MEADOWBROOK CROSSING

# MEADOWBROOK CROSSING PRELIMINARY LANDSCAPE PLAN

PCD PROJECT NUMBER: SP-17-002

C1

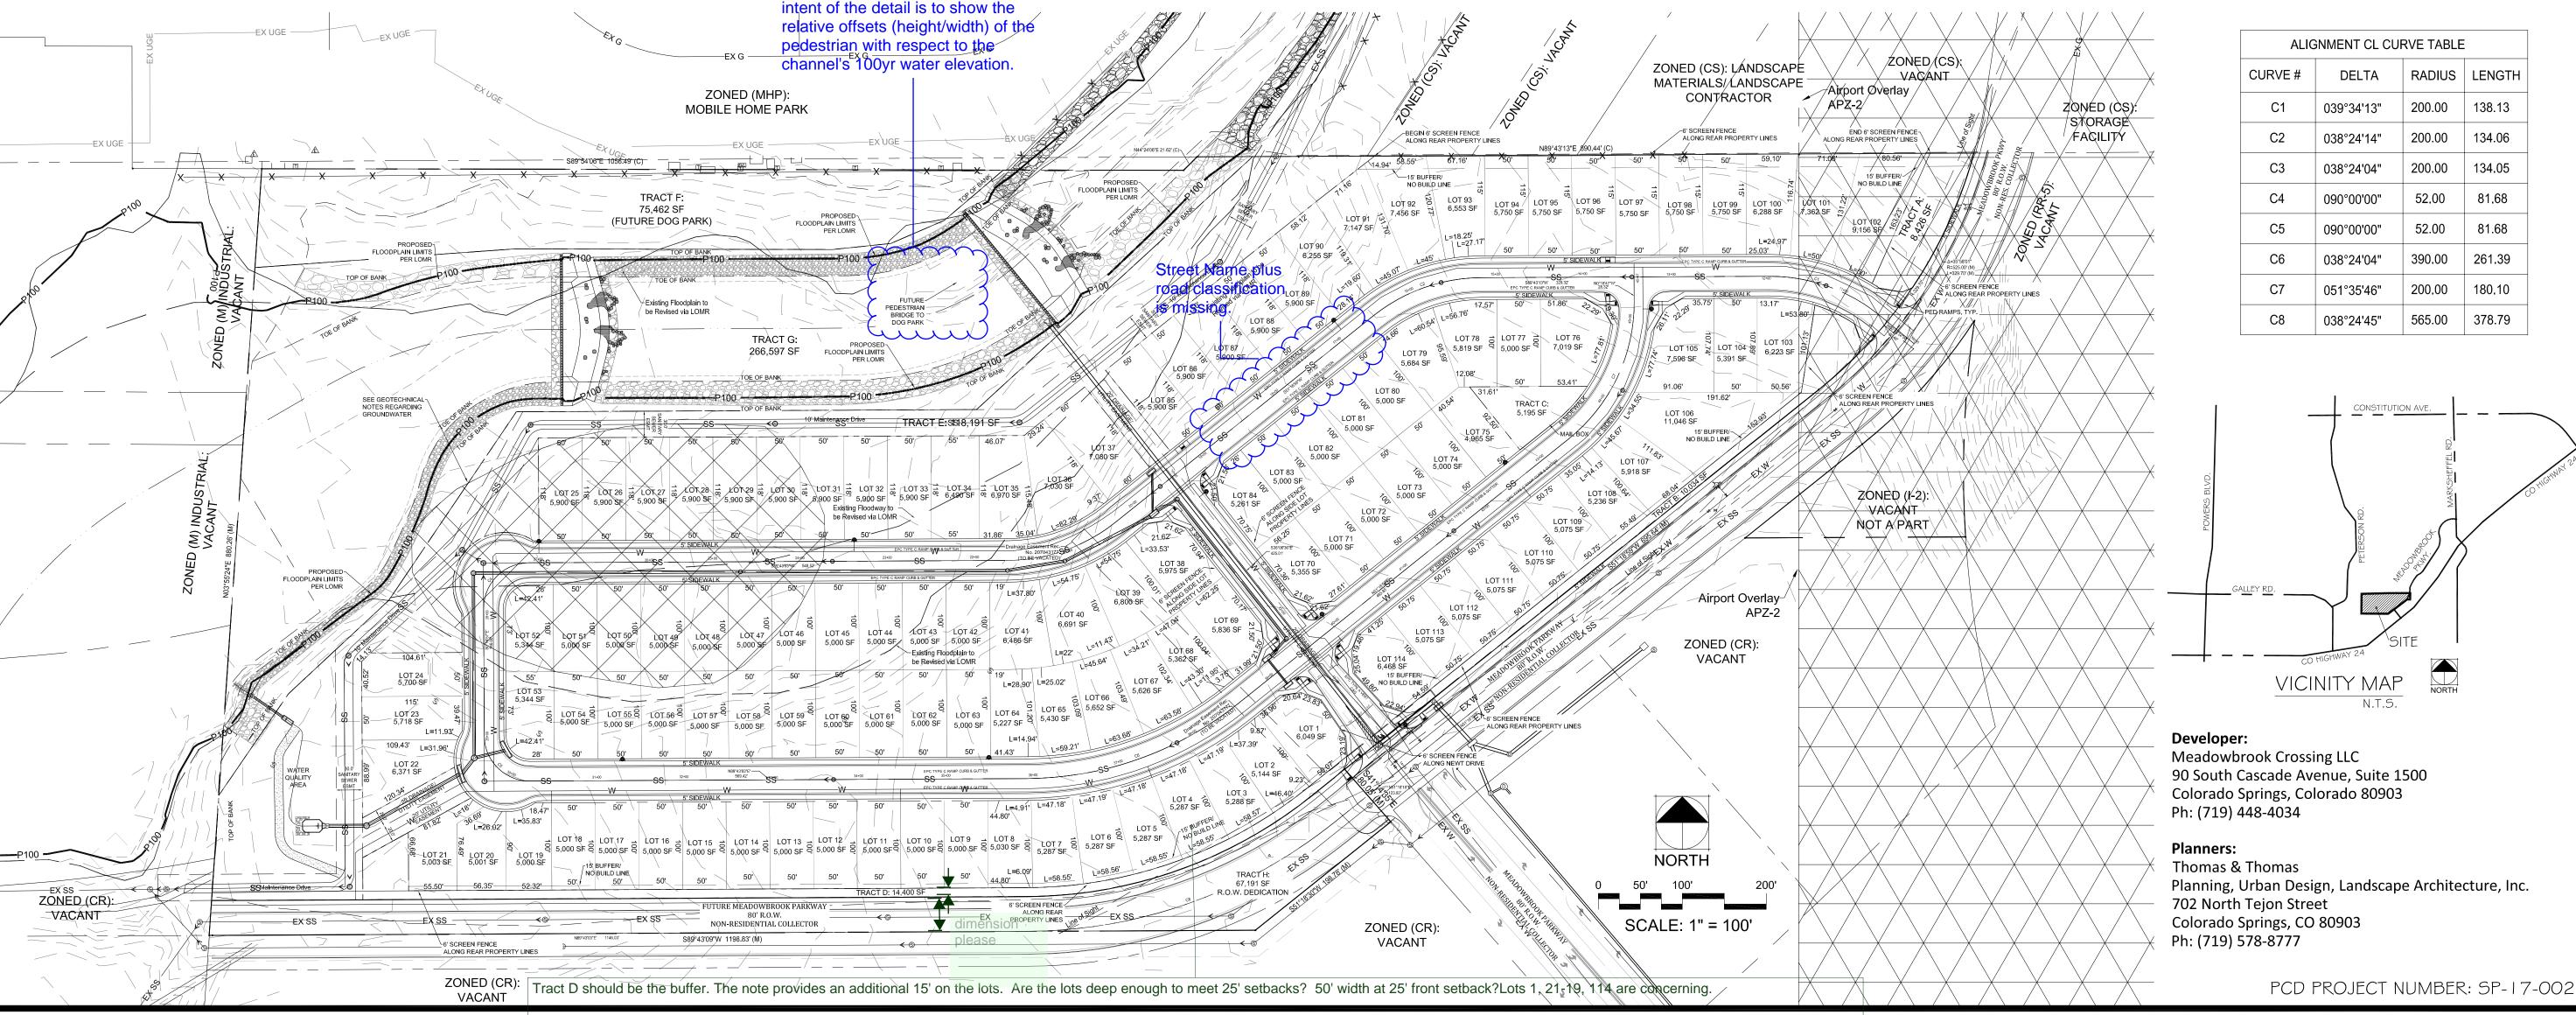
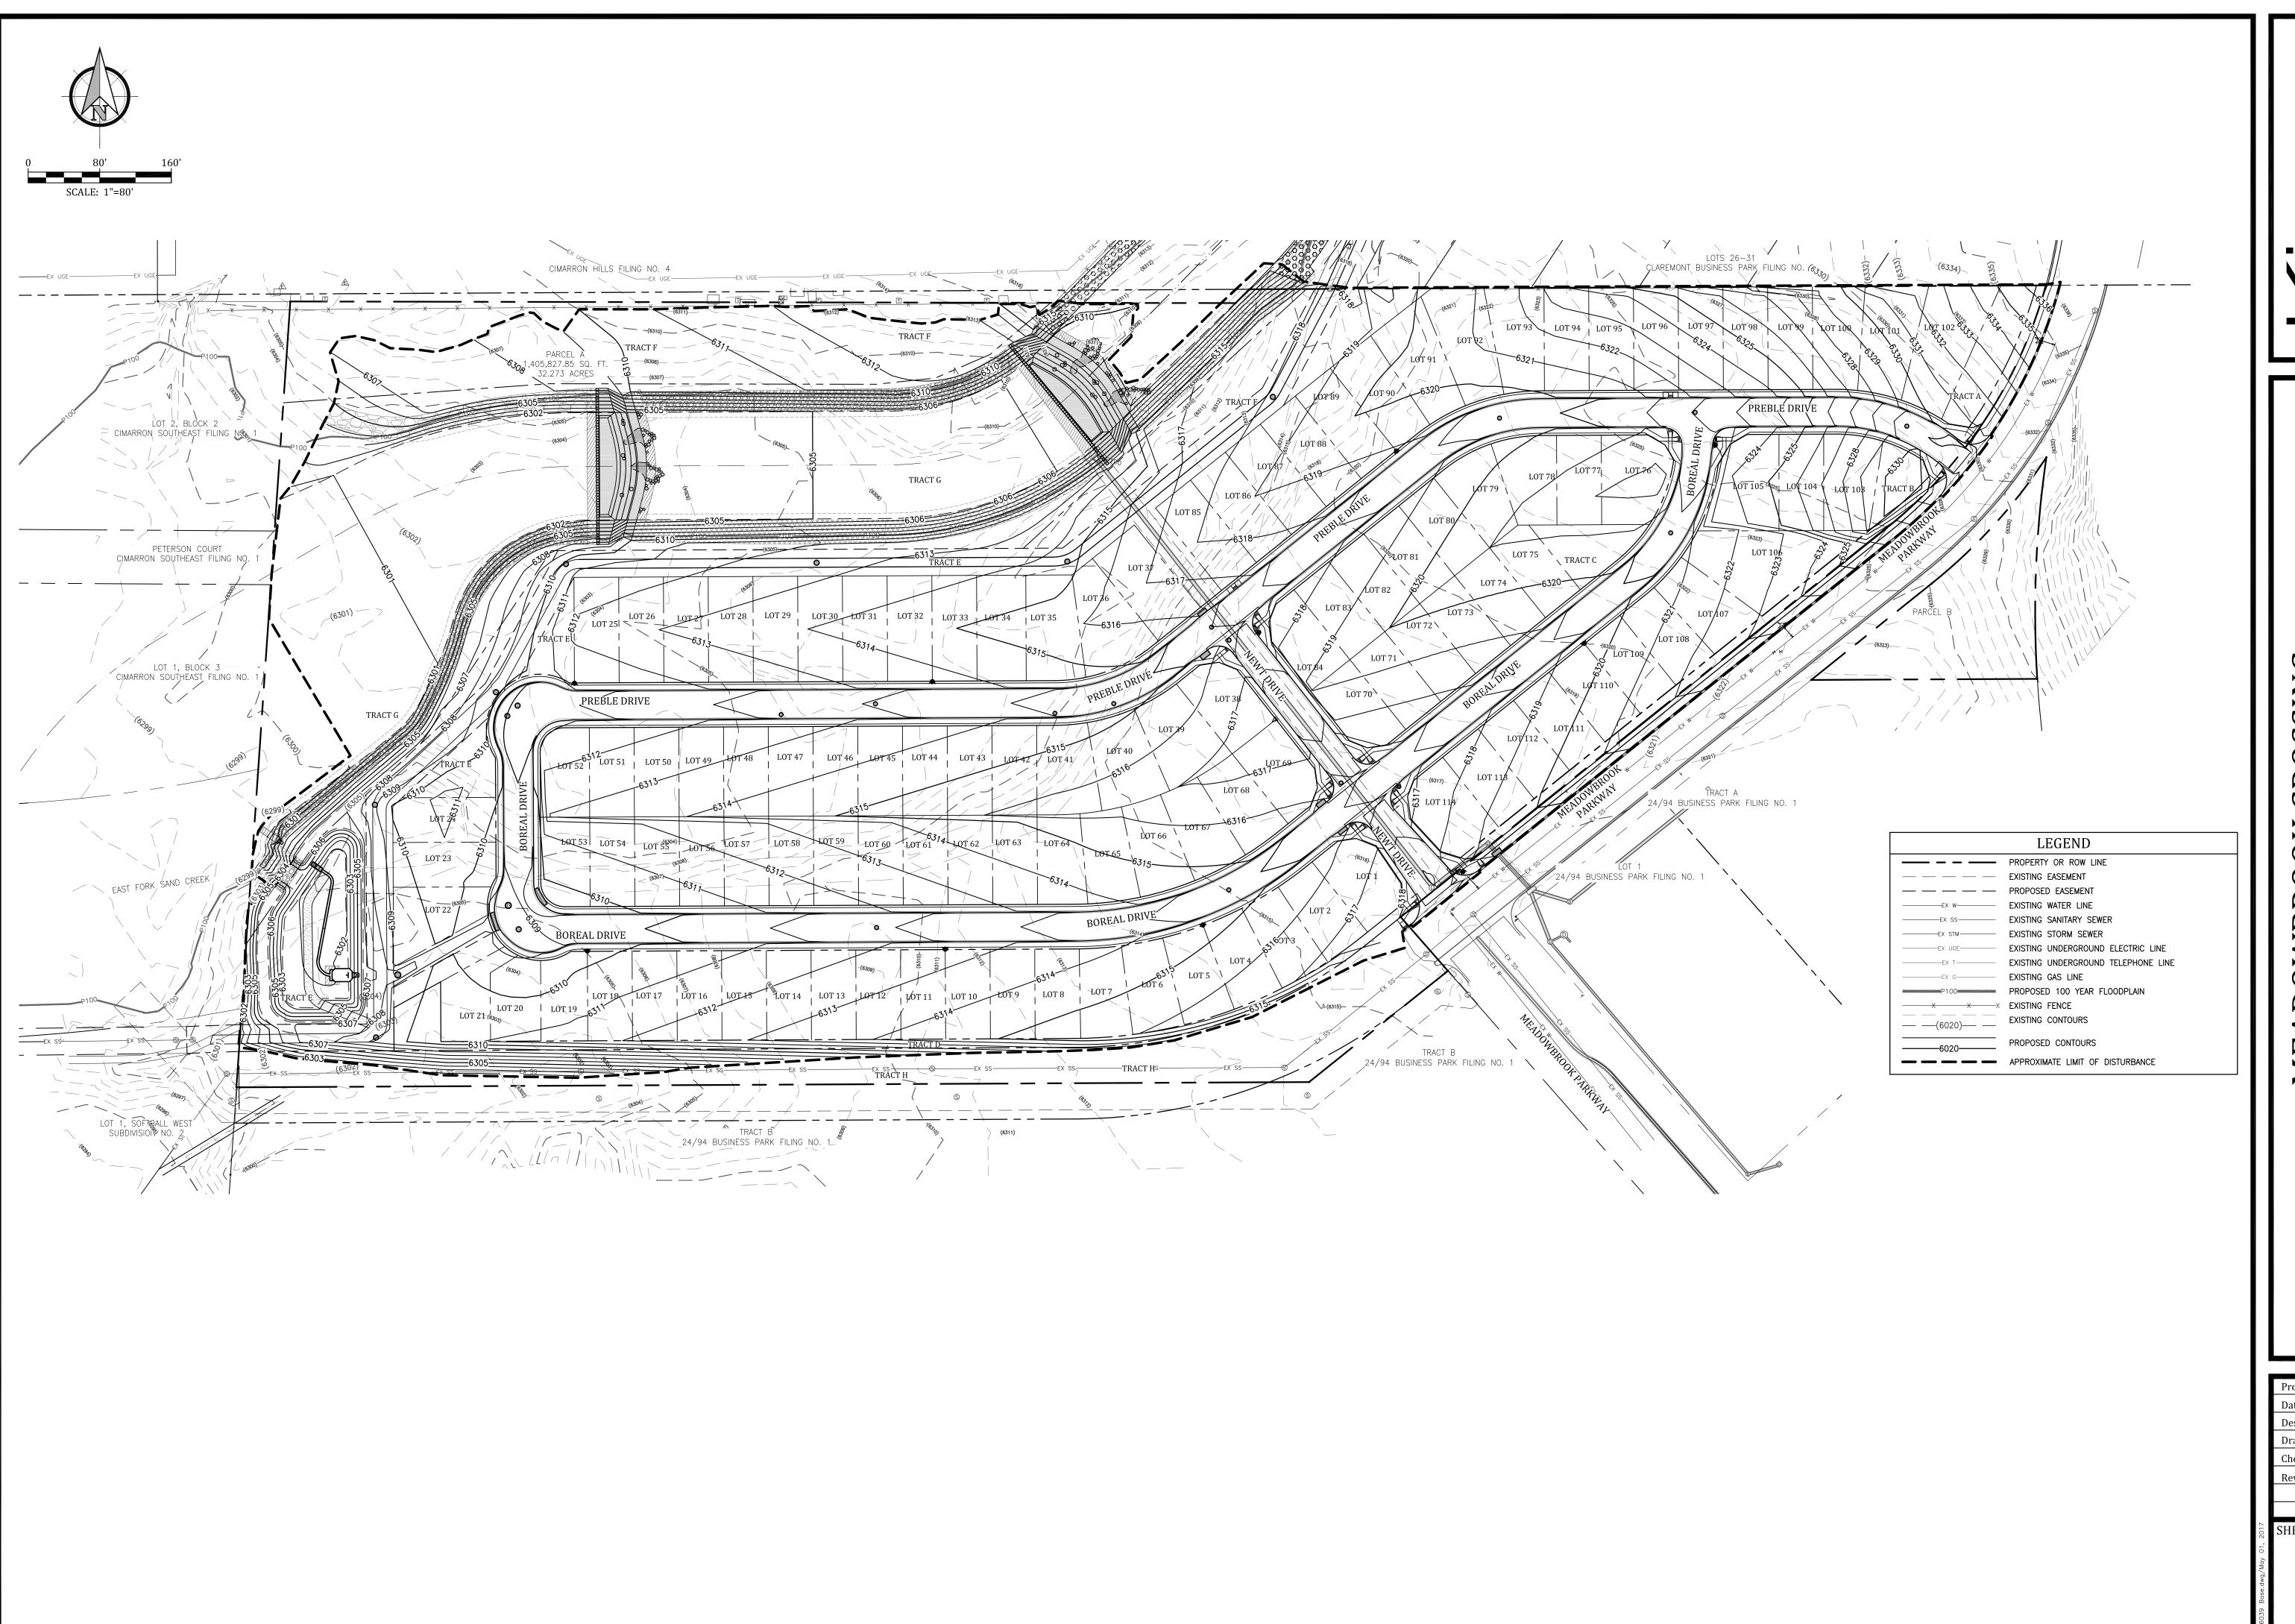
Show the pedestrian bridge linework and add a profile detail. The main

Show the pedestrian bridge linework and add a profile detail. The main intent of the detail is to show the relative offsets (height/width) of the pedestrian with respect to the channel's 100yr water elevation.

ENTRANCE SIGNAGE-CONCEPT DESIGN **ELEVATION**

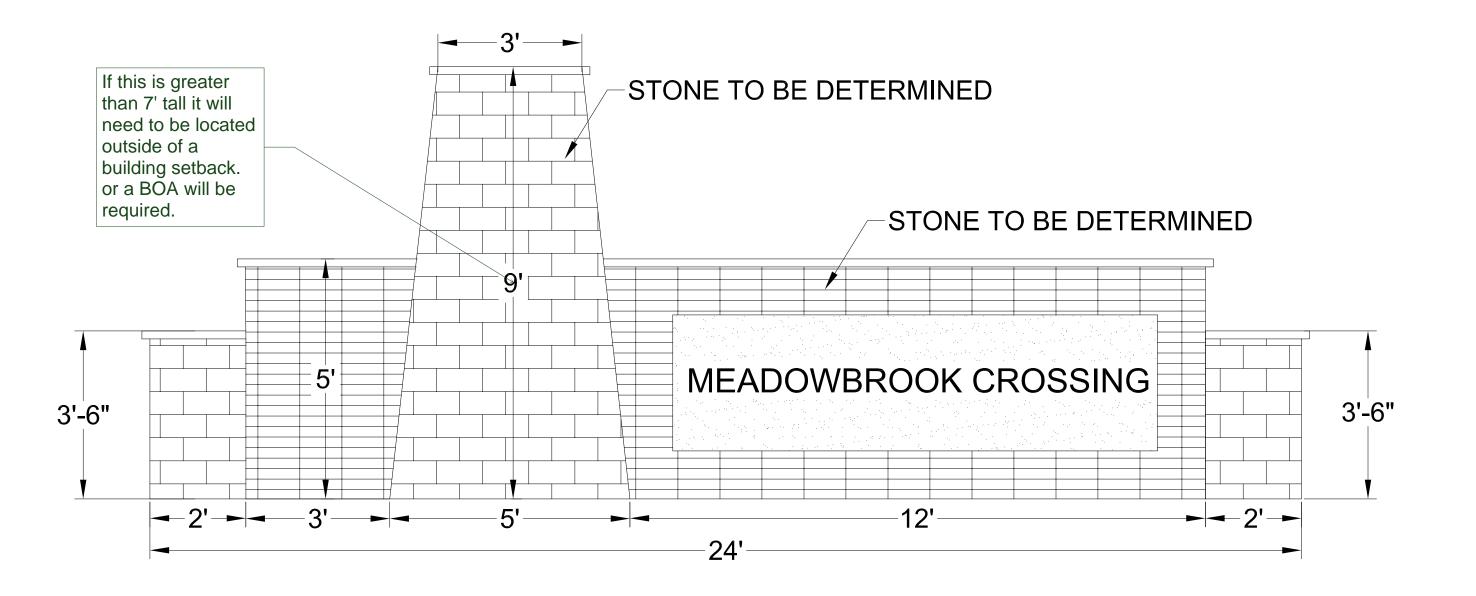
If this is greater than 7' tall it will need to be located outside of a building setback. or a BOA will be

required.
